Amendments to the Drawing Figures

REPLY

FIG 1

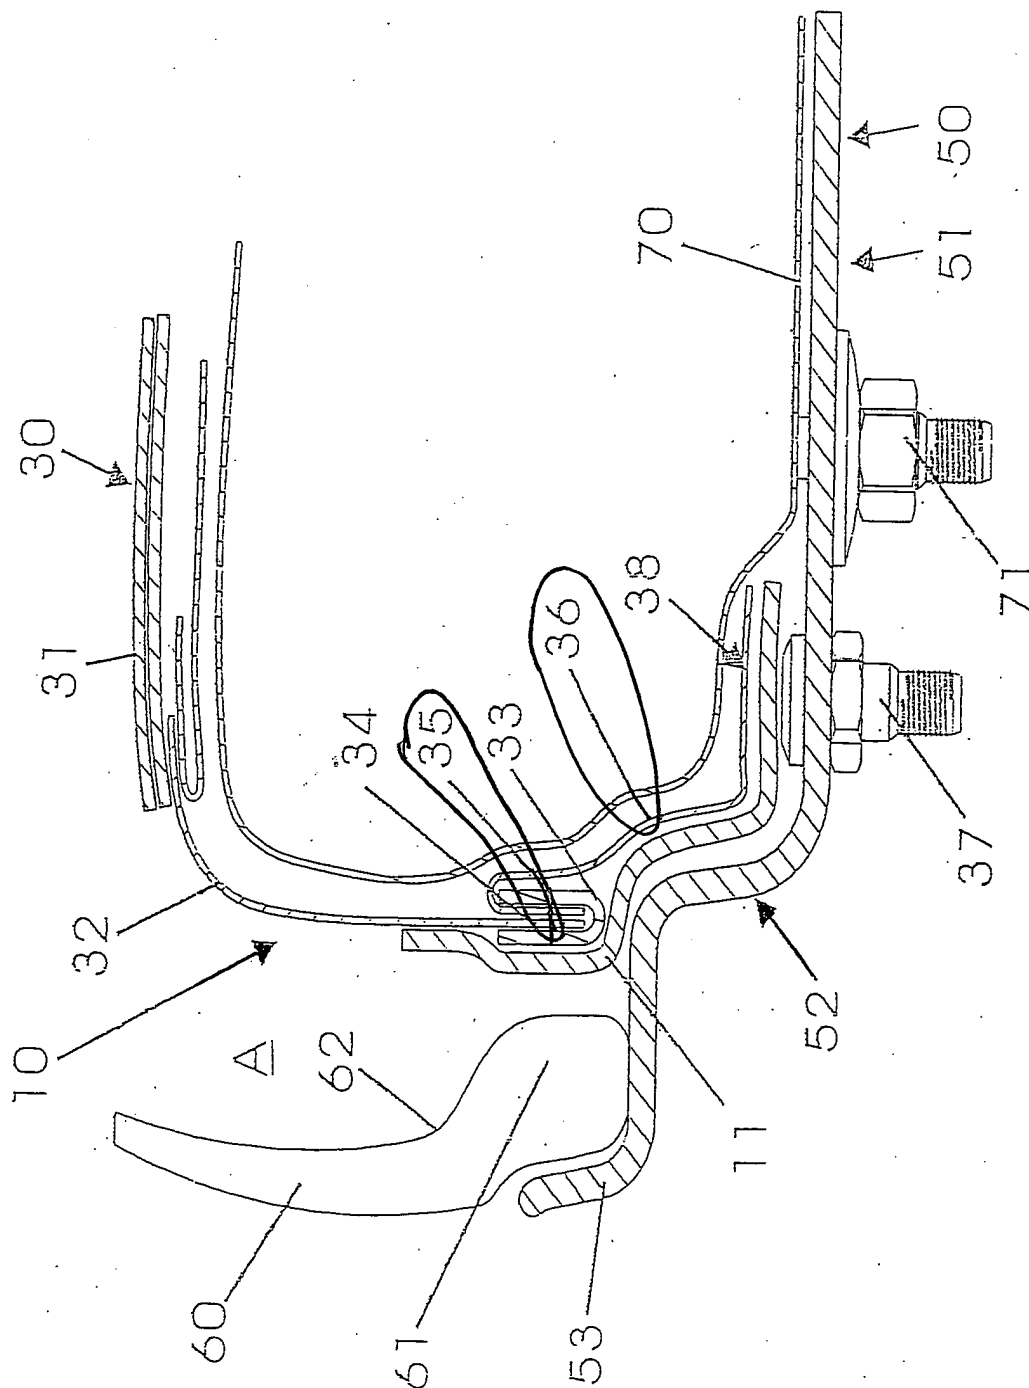
The Examiner objected to the drawings because the lead lines in the reference characters 35 and 36 in Fig. 1 point to the wrong element. **Enclosed** with this Amendment and Reply is a Replacement Sheet that corrects the lead lines on reference characters 35 and 36 in Fig. 1 to point to the correct element. For clarity, the stitching 35 has been included in Fig. 1. Support for including the stitching 35 in Fig. 1 can be found on page 8, lines 5-14 of the specification, and illustrated in Fig. 3. Additionally **enclosed** with this Amendment and Reply is a Replacement Sheet for Fig. 3 that more clearly labels the stitching 35.

The Examiner also objected to the drawings, indicating that the insertion bead 33 adapted to push against the tire bead as set forth in claims 1 and 16 must be shown or the feature canceled from the claims. It is respectfully submitted that this feature is shown or illustrated in Fig. 1. The insert bead 33 is attached to sidewalls 32 which are permitted to expand or move axially when the inner tube 70 is inflated. Accordingly, the insert bead 33 is forced axially toward the tire bead 61 so as to push up against it. The elements claimed are shown in the drawings. The operation of the invention, including the insert

Enclosed are a Replacement Sheet and Annotated Marked-Up Drawing for Fig. 1. The lead lines for elements 35 and 36 have been extended.

bead 33 being pushed against the tire bead 61 during implementation of the invention, is clearly described and appreciated in view of the specification. Therefore, no further drawing amendment is believed to be necessary.
